VICTORVILLE 2 HYBRID POWER PROJECT (07-AFC-01)
CEC STAFF DATA REQUEST NUMBERS 85-90

Technical Area: Traffic and Transportation

Response Date: July 23, 2007

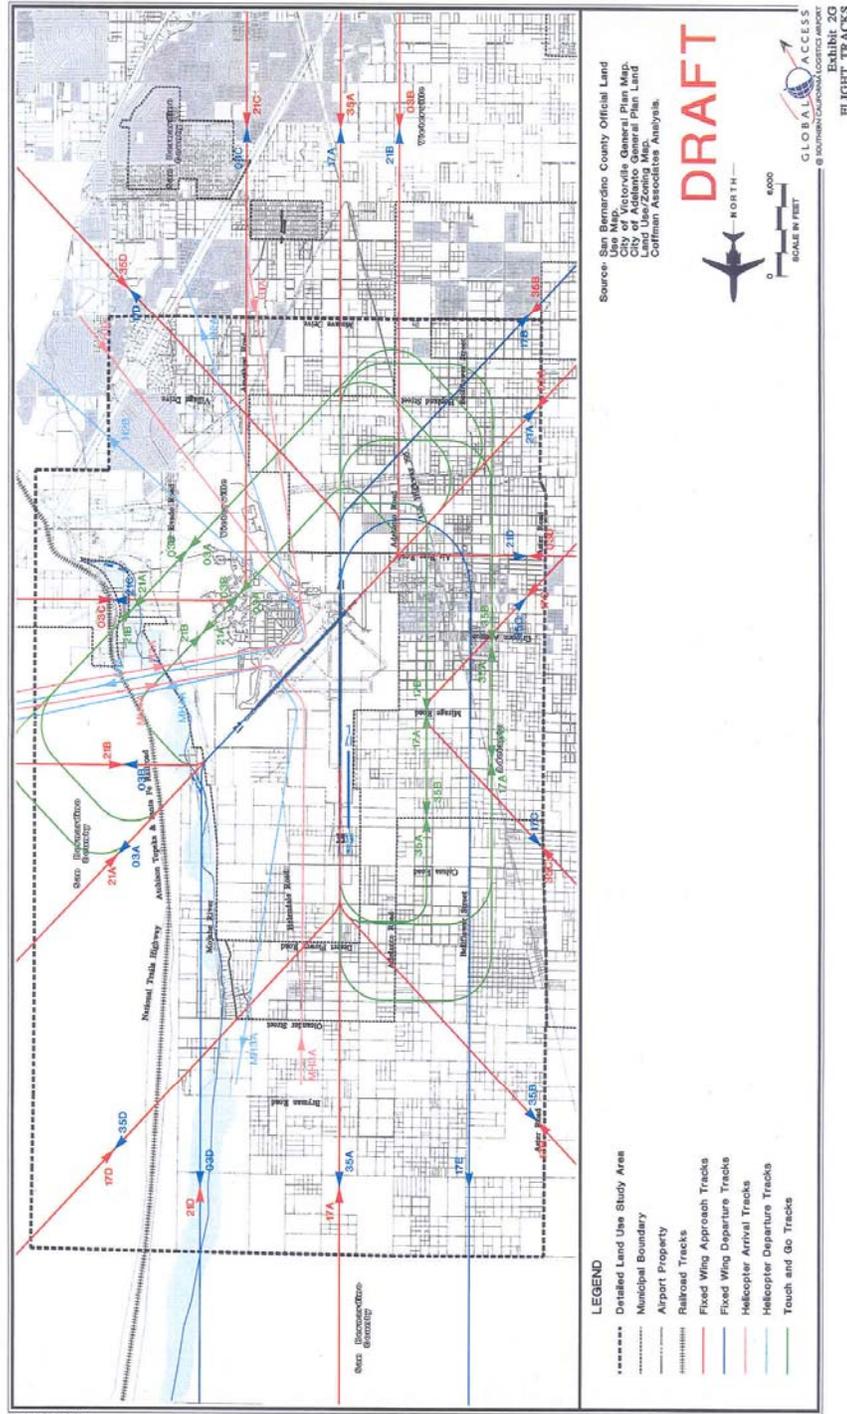
Please provide figures indicating flight tracks between 400 – 1,000 feet agl in the area above the proposed project site and within 300 feet of the site boundaries, over a period of 30 consecutive days as follows:

- a. Separate figures for single engine, multi-engine, and helicopter; and
- b. In addition to a single composite figure for all altitude tracks, please include separate track figures for at least three levels between 400 and 1,000 feet agl, preferably 400-600 feet agl, 601-800 feet agl, and 801-1,000 feet agl, or representative altitudes within these parameters.

Figure DR88-1 shows the Consolidated Flight Tracks for the various kinds of operations at SCLA. This figure is taken from the soon-to-be-completed SCLA Comprehensive Land Use Plan. No figures are available that show flight tracks separately for different kinds of aircraft or for different altitudes. According to SCLA officials, the Consolidated Flight Tracks are the result of interviews with Air Traffic Control (ATC) Tower staff and review of local and regional air traffic control procedures (personal communication, Peter Soderquist, SCLA, July 2007). Consolidated Flight Tracks depict average corridors that lead to and from an airport. Aircraft traffic can be expected over most areas around an airport, with air traffic density generally increasing closer to the airport. These flight tracks were developed to reflect these common patterns and attempt to account for flight dispersion around SCLA. They do not reflect or suggest any given altitude. Aircraft altitude is driven by type of aircraft, the type of approach (or departure) being flown, weather, and Air Traffic Control.

If the pilot elects to circle-to-land to Runway 21 prior to reaching Decision Height, he/she may overfly the VV2 Project. Aircraft height above the ground at that time is unknown. It will be above the altitudes referenced above, and probably higher. Safety of flight rules dictate that aircraft be established on a stabilized approach (i.e., on a stable glide path at the proper speed and altitude) prior to landing. "Safe or deemed necessary" governs a pilot's decision to circle-to-land. While 600 feet AGL is a "legal" minimum, it would not be commonplace. Discussions with Air Traffic Control Tower staff suggest aircraft that circle to land on Runway 21 are generally higher than 600 feet. This is due to the pilot's desire to establish a stabilized approach prior to landing on Runway 21.
